Proposal Request

Project:
Intermountain Healthcare Lake Park Level 1 Remodel
2545 College Drive
Murray, Utah 84123

Date: 02/11/2021
Proposal Request
PR # 01

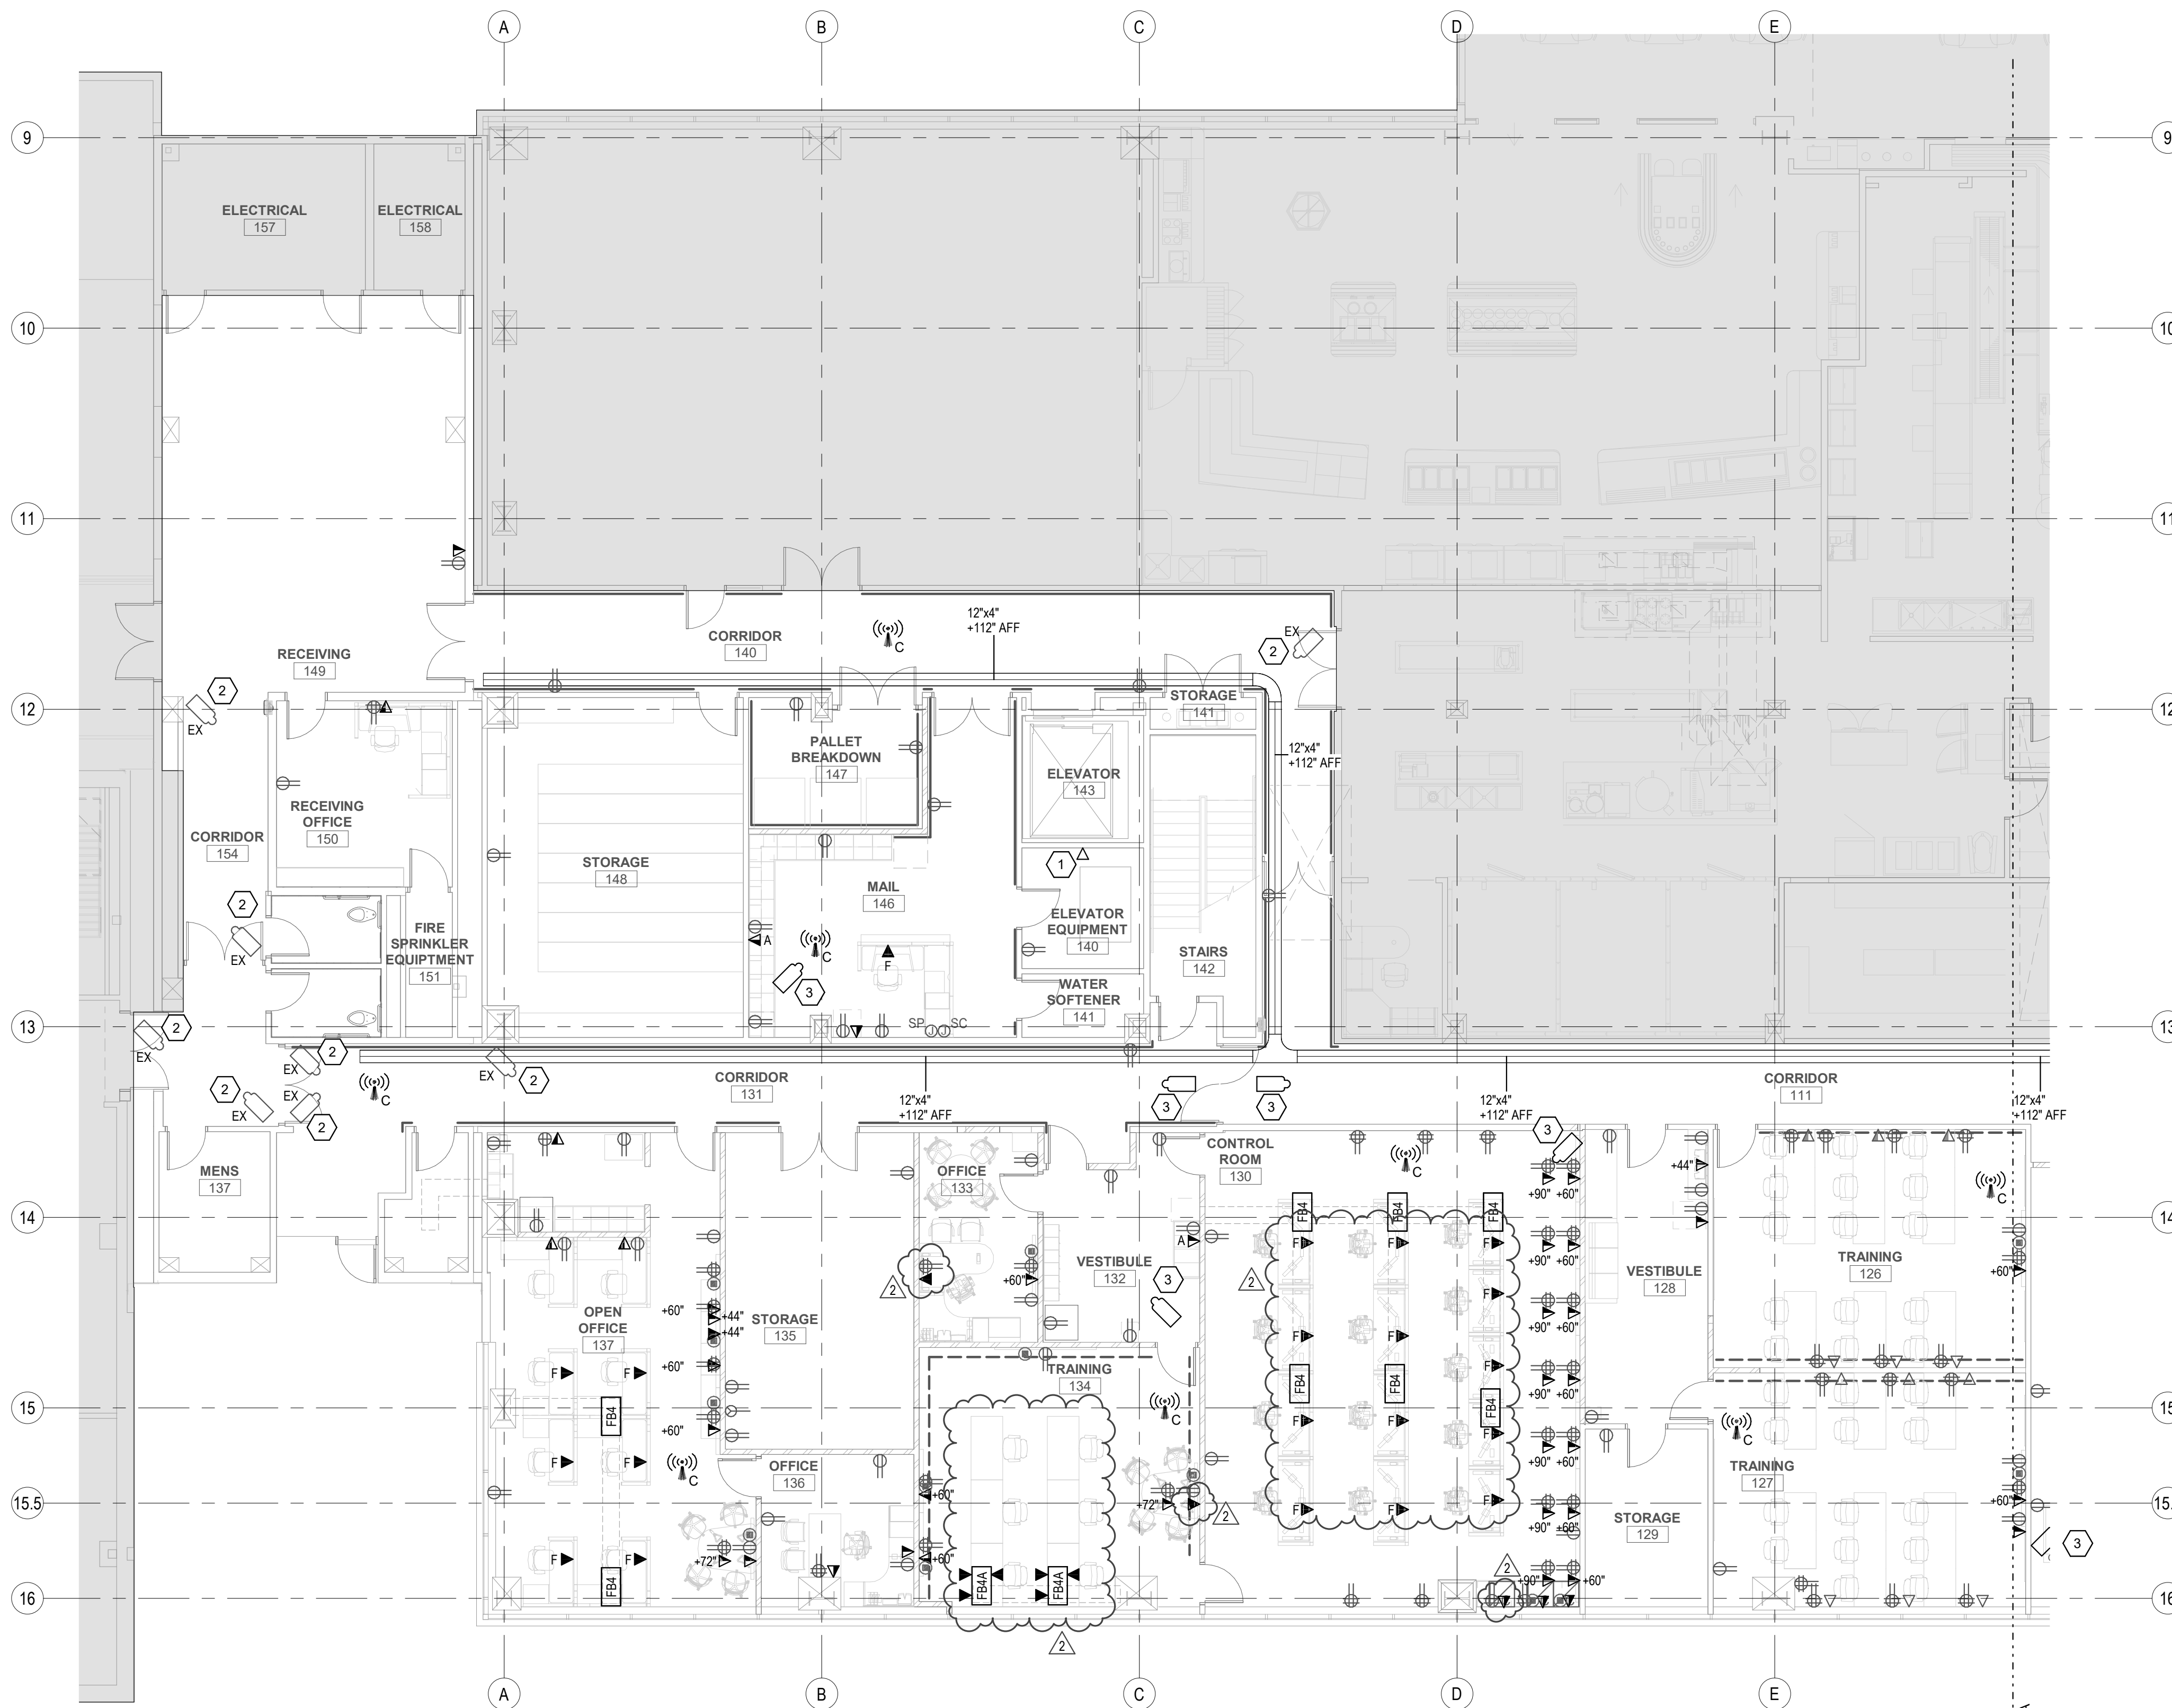
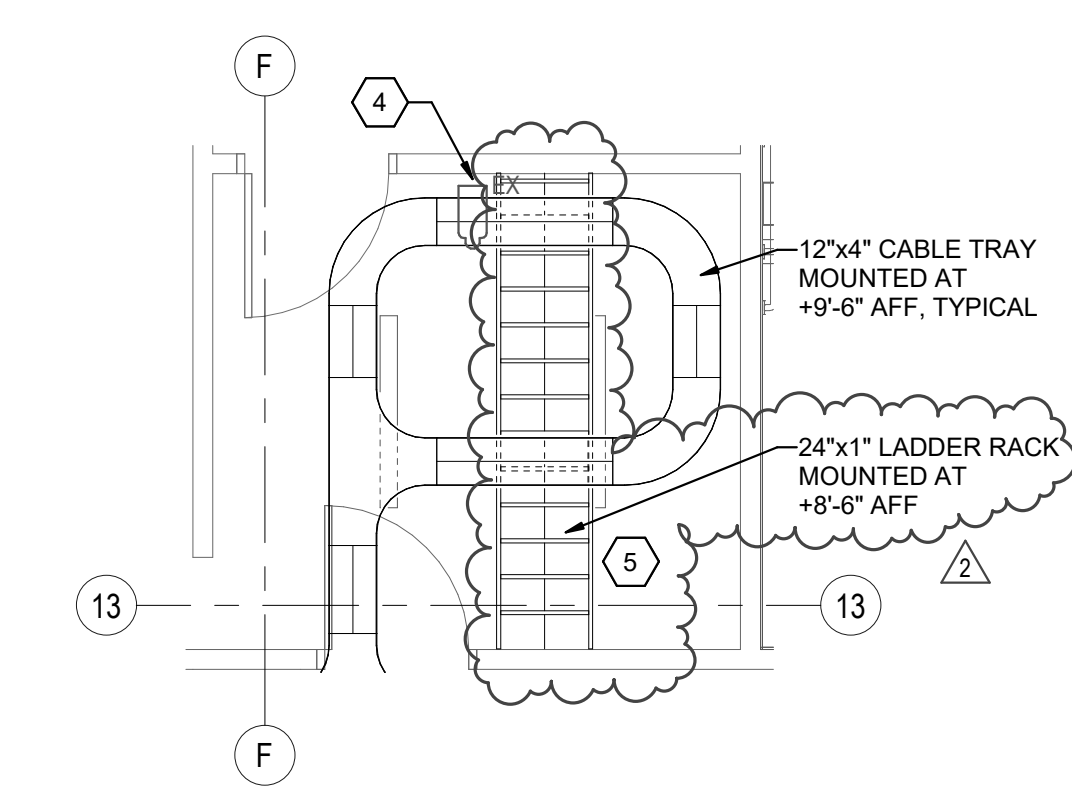
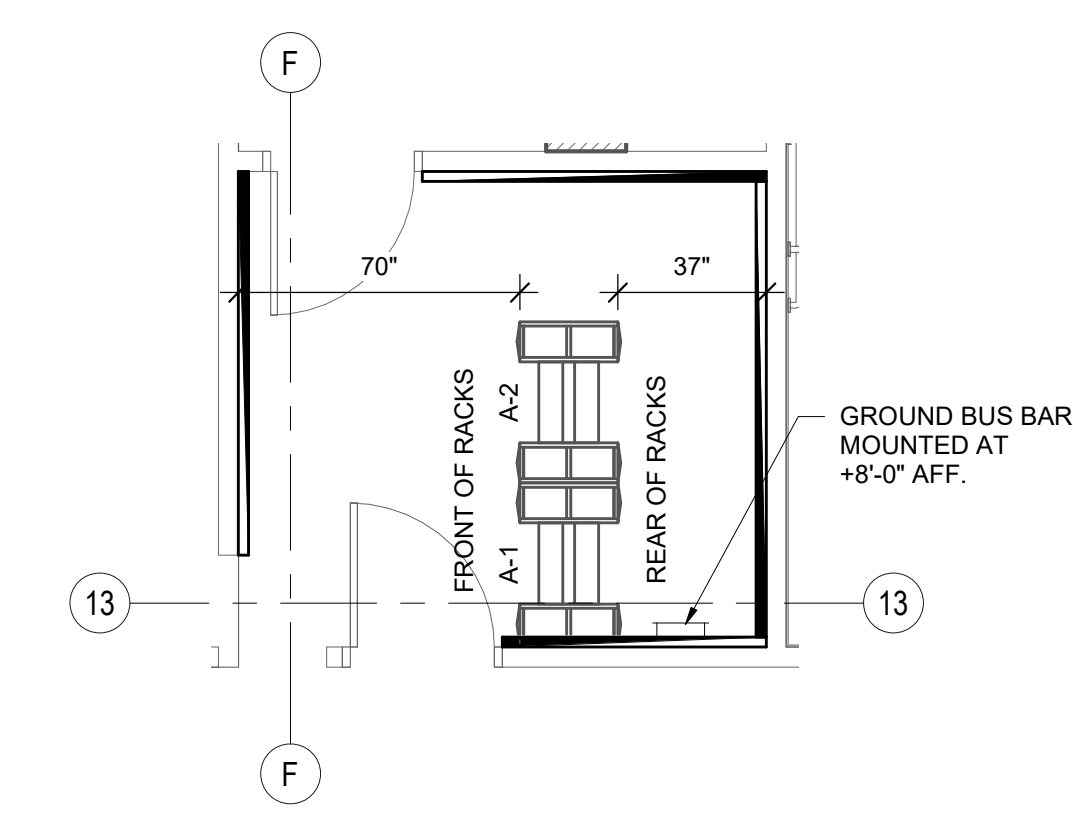
1. ET101A: Conduit to floor boxes shown on ET601. Conference Room 114 moved data from wall to column. Added data location for TV Conference Room 114. Detail C5 for enlarge TDR plan added ladder rack. Added sheet keynote #5.
2. ET101B: Changed data in Control Rom 130, Office 133, and Training 134 from two port faceplates to three port devices in floor box locations.
3. ET501: Updated data device schedule.
4. ET601 Detail D1 changed to show one cable from each 3 port faceplate to terminate in Control Room 130.
5. EJ101B: Added sheet keynote #5, added IT rack in Control Room 130 cabinet to match audio visual racks (provided by Marshall). Installation details to be coordinated between Cache Valley, Marshall and all other applicable trades.
